To be held on Monday, May 26, 2014 at **2:00 p.m.** Committee Members are asked to meet in the **Council Chambers** at 395 Mulock Drive, Newmarket, Ontario.

1. REQUEST FOR EXEMPTION FROM SITE PLAN APPROVAL p. 1
380 BAYVIEW AVENUE - WARD 3
(WEST SIDE OF BAYVIEW PARKWAY, NORTH OF ELGIN STREET)
(OWNER: THE REGIONAL MUNICIPALITY OF YORK)

2. APPLICATION FOR SITE PLAN APPROVAL p. 16
17150 YONGE STREET - WARD 7
(NORTH SIDE OF EAGLE STREET, WEST SIDE OF YONGE STREET)
OUR FILE NO.: D11-NP1403
THE REGIONAL MUNICIPALITY OF YORK

SITE PLAN REVIEW – 17150 YONGE STREET

DWG. NO. C-001
CONT. NO. T-13-58
SHEET NO. 5

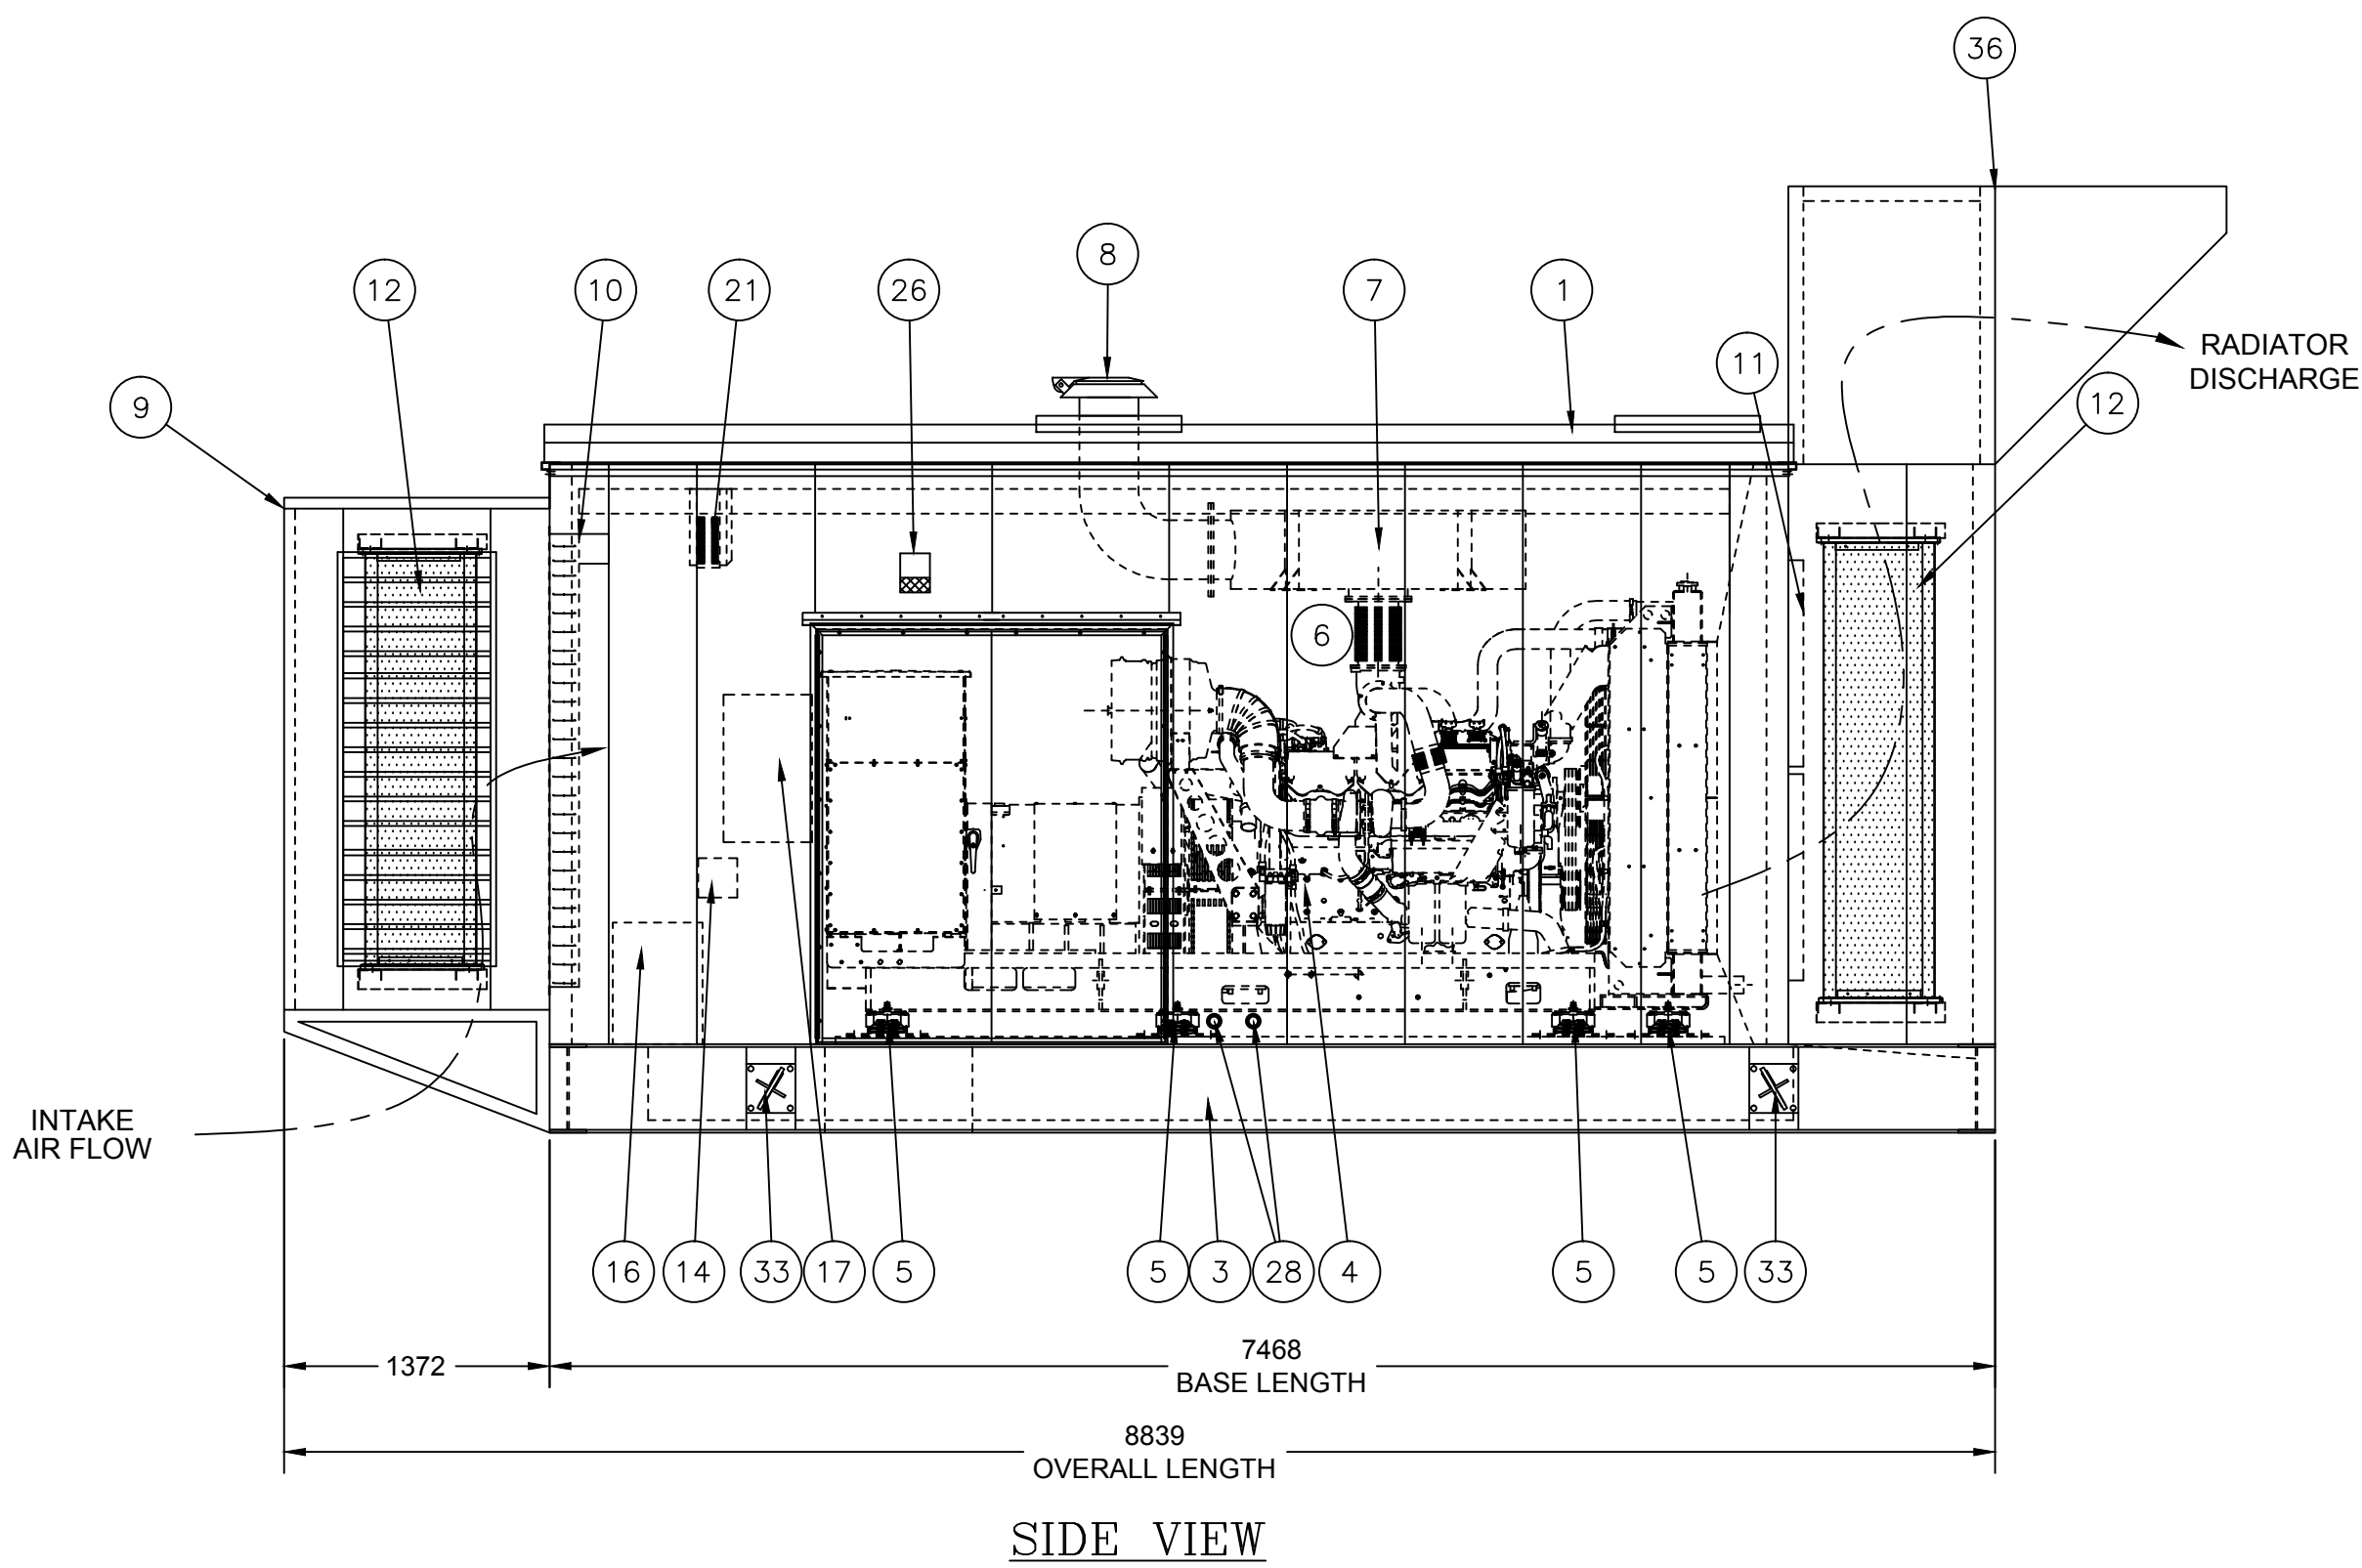
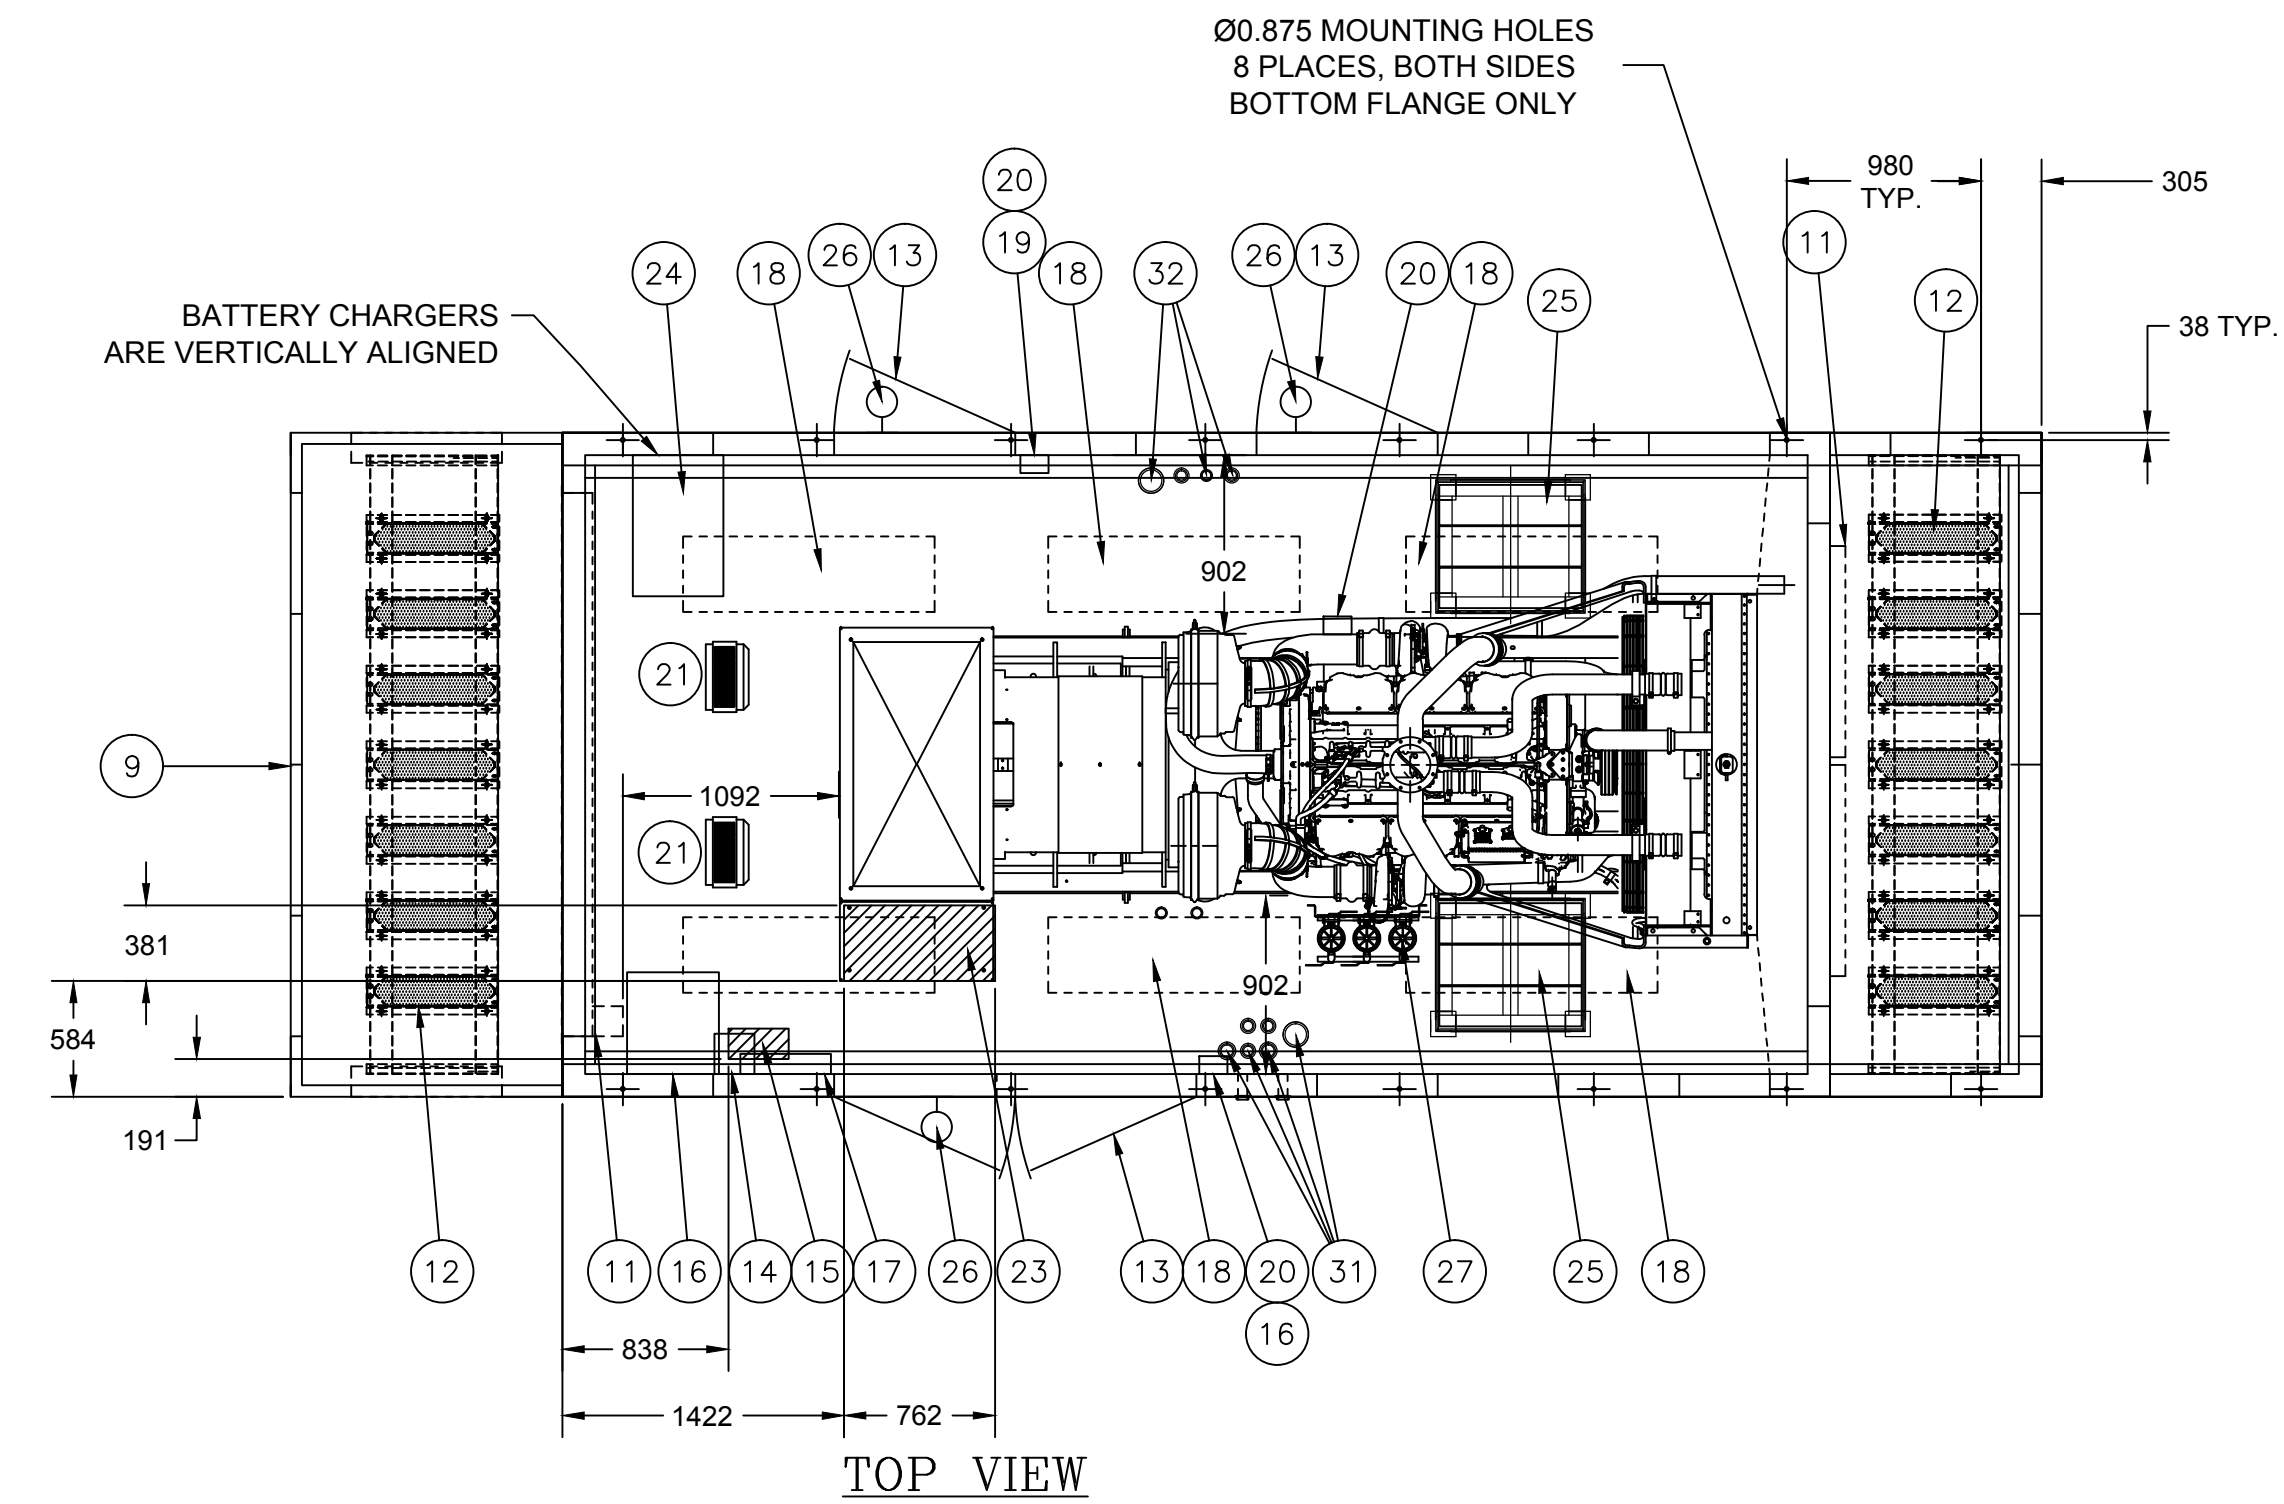
To reduce the visual impact of the generator enclosure from the residential neighbourhood and surrounding area, we are enhancing the facility with landscaping, which includes planting a live visual screen as shown on the attached site plan drawing, *C-001*. Furthermore, a fence will also provide additional visual screening, especially during the growth period of the plantings. Finally, the generator enclosure will be supplied in a colour chosen to blend into the environment.

DESIGN M.B.	NEWMARKET SEWAGE PUMPING STATION UPGRADES GENERATOR - OUTDOOR ENCLOSURE	DWG. NO. E-621
DRAWN Y.O.		CONT. NO. T-13-58
CHECKED M.B.		SHEET NO. 77

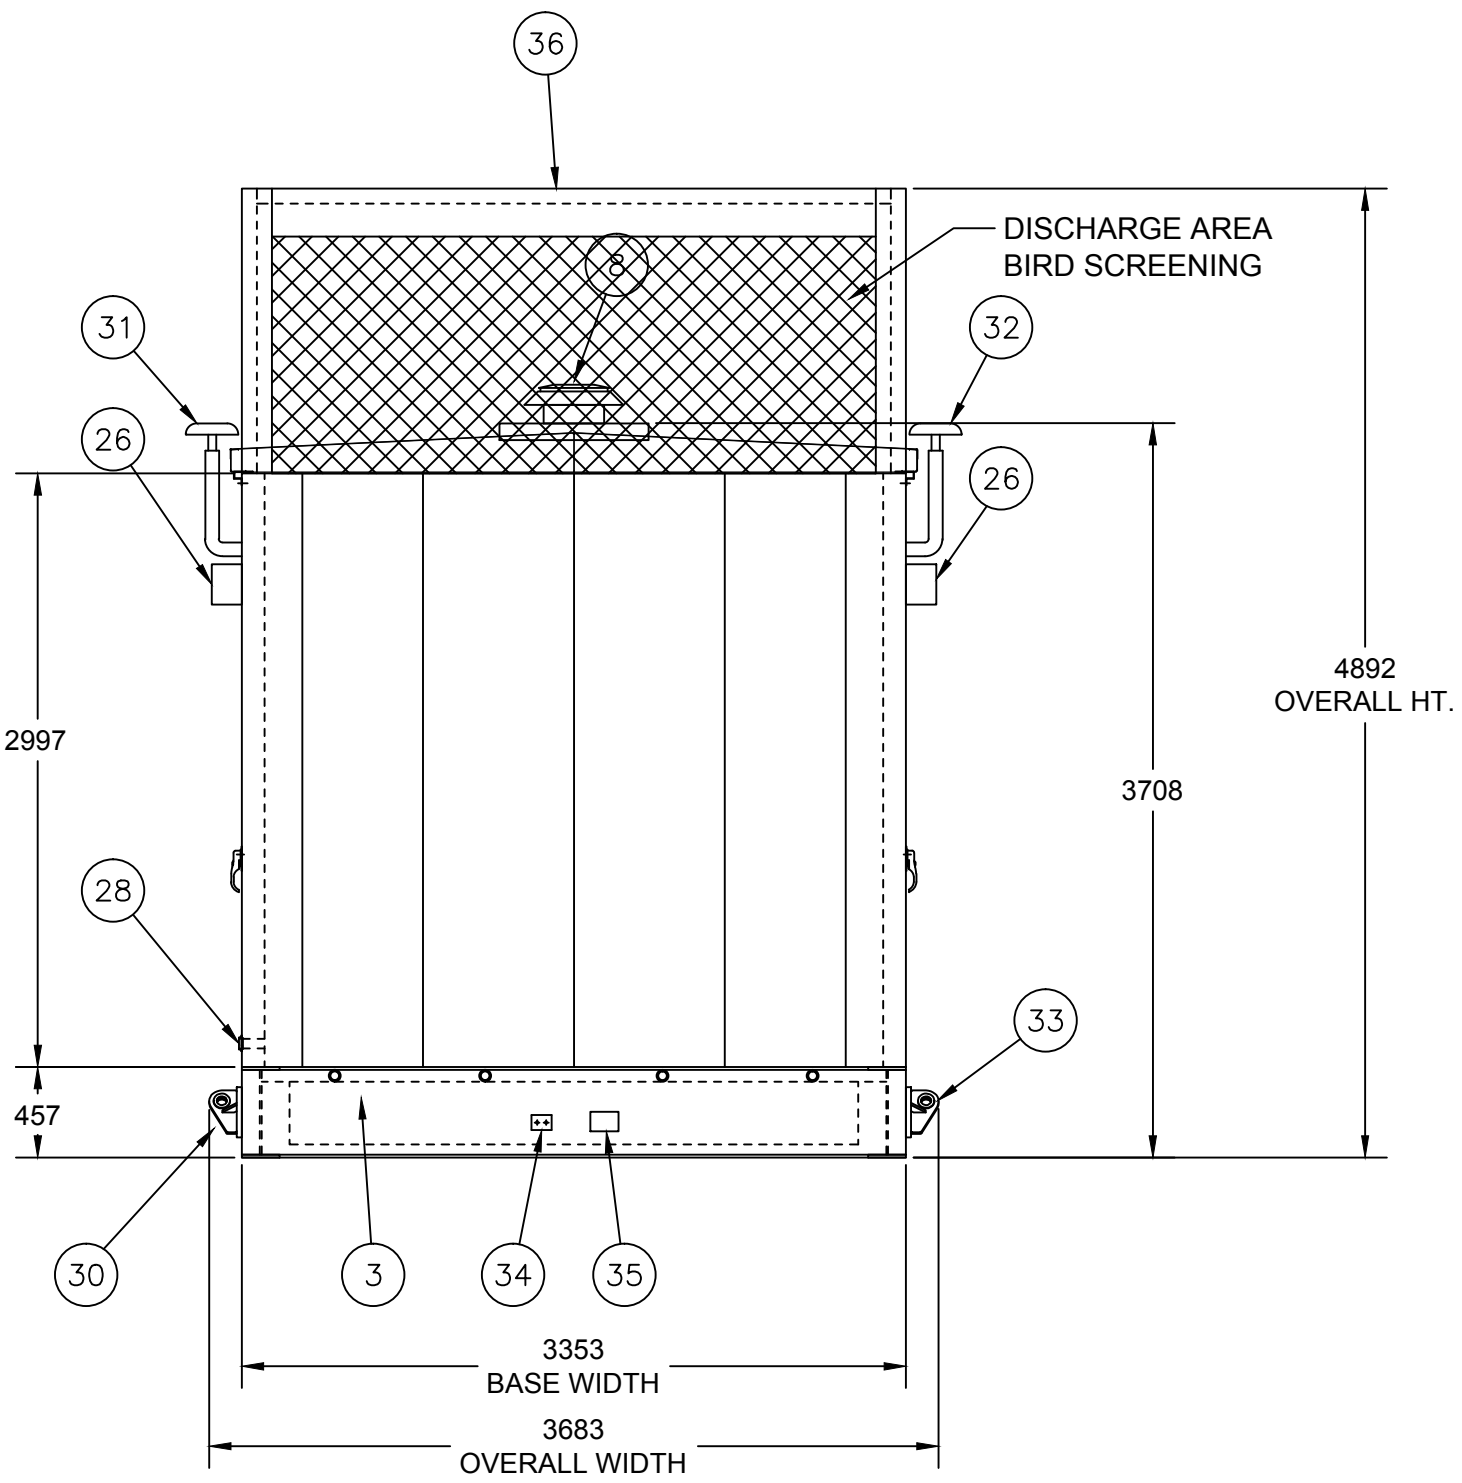
The proposed emergency generator will be installed to the east of the station on a concrete pad at grade with approximate dimensions of 9.4m by 3.9m. The generator will be inside a steel sound attenuating enclosure approximately 8.8m by 3.9m by 3.7m high. The diesel fuel is contained in a fuel tank that is integral with the generator base frame. The total weight of the generator with enclosure and fuel is approximately 30,000kg. Please refer to the attached drawing *E-621* detailing the dimensions and configuration of the generator. The Generator has been selected to meet, or exceed, MOE guidelines for both noise and air emissions. This should provide an overall improvement to the environment during operation of the generators, since generator technology has improved significantly over the years since the original construction of the facility.
